UNITED STATES PATENT AND TRADEMARK OFFICE

Office Action Summary

10/689,092

DETAILED ACTION

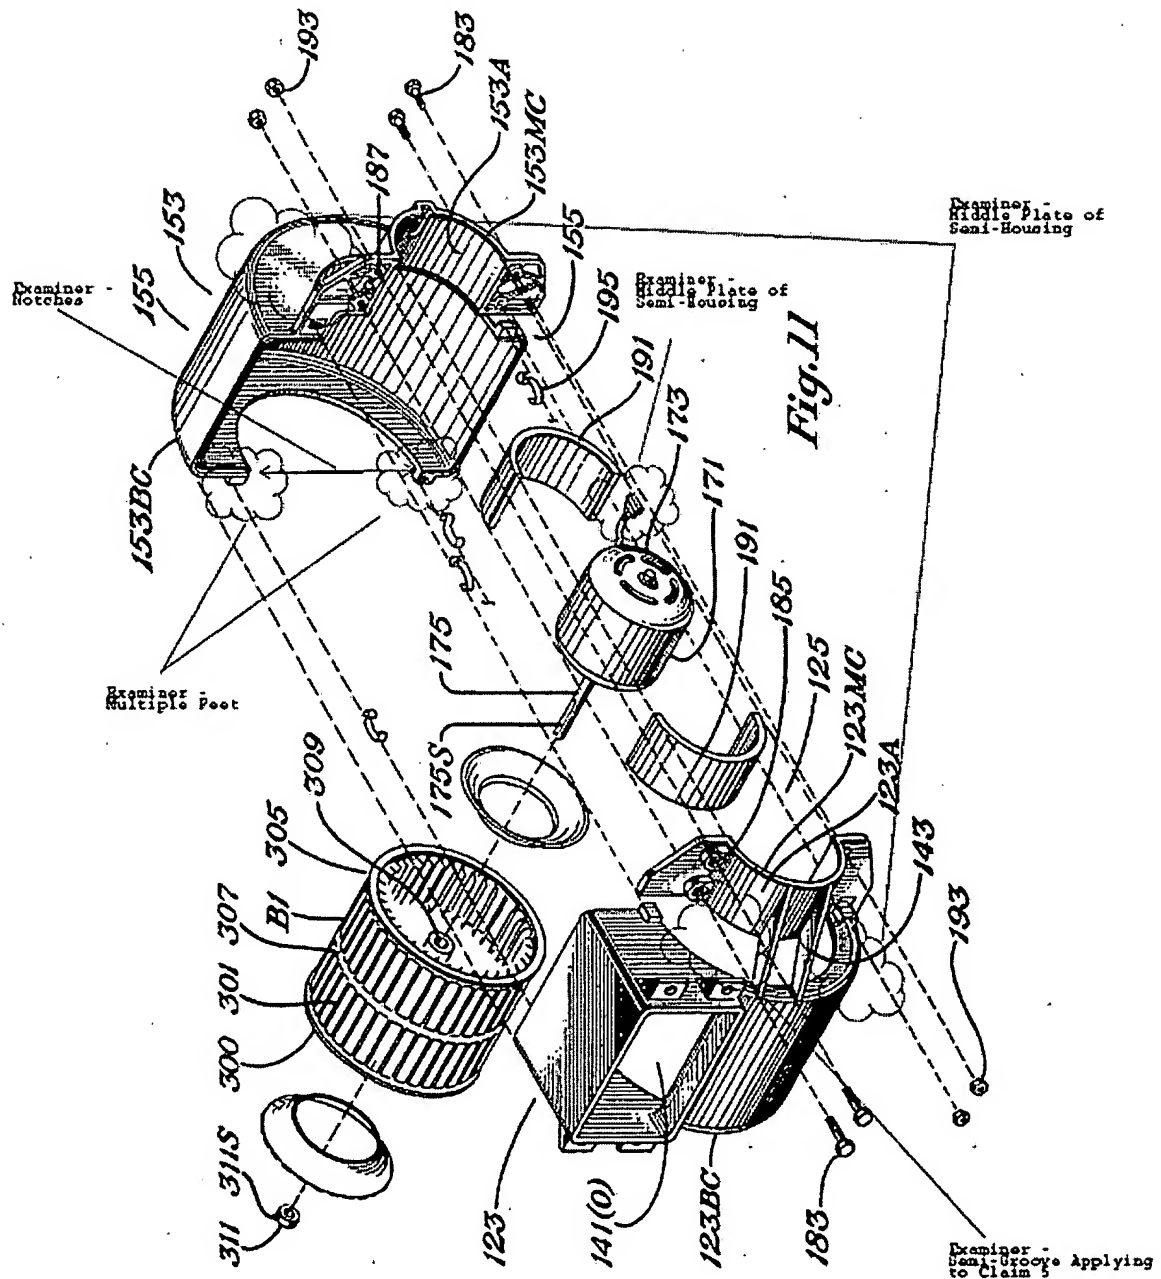
5. Claims 1, 2, and 5 are rejected under 35 U.S.C. 103(a) as being unpatentable over Murphy (US Patent No. 5,403,163) in view of Bradbury et al. et al. (US Patent No. 6,129,528) and Kenny et al. (US Patent No. 3,322,331) . With regards to claim 1 Murphy '163 teaches a housing being composed of two symmetrical semi-housings (Murphy – Figure 11 articles 123 and 153), wherein each semi-housing has multiple feet formed at a lower side thereof (Murphy –

Figure 11 articles 123 and 153), multiple notches respectively defined between the feet (Murphy – Figure 11 articles 123 and 153), an upper plate formed at an upper portion of said semi-housings (Murphy – Figure 11 articles 123MC and 153MC). Further Murphy '163 teaches that top of the intermediate surface of articles 123 and 153 (symmetrical semi-housings), joined to the top portions shown as 123A and 153A by article 143, serve as middle plates formed at a middle portions of said semi-housings (Murphy – Figure 11 articles 123 and 153). Murphy '163 teaches an air impeller mounted between the bottom plate and the middle plate of the semi-housings (Murphy – Figure 11 article B1), and a motor mounted between the middle plate and the upper plate of the semi-housings (Murphy – Figure 11 articles 173), and having an output axle extending downwards for driving the air impeller (Murphy – Figure 11 article 175). With regards to claim 2 of the claimed invention, the semi-housings taught by articles 123 and 153 by Murphy '163 in Figure 11 are cylindrical. With regards to claim 5 of the claimed invention, the area in between articles 153 and 153A, and 123 and 123A, and bridged by article 143 form matching semi-grooves transversely defined at an outer periphery. Figure 11 of Murphy '163 is included in this document for reference on the following page.

Murphy '163 does not teach that the top and bottom plates of the symmetrical semi-housings have multiple air inlets or multiple air outlets defined through a surface of the said plates, rather there is a single void or gap in each instance. Further Murphy '163 does not teach a circuit board installed in the housing and electrically connected with the motor although there is a means for making an electrical connection to the motor.
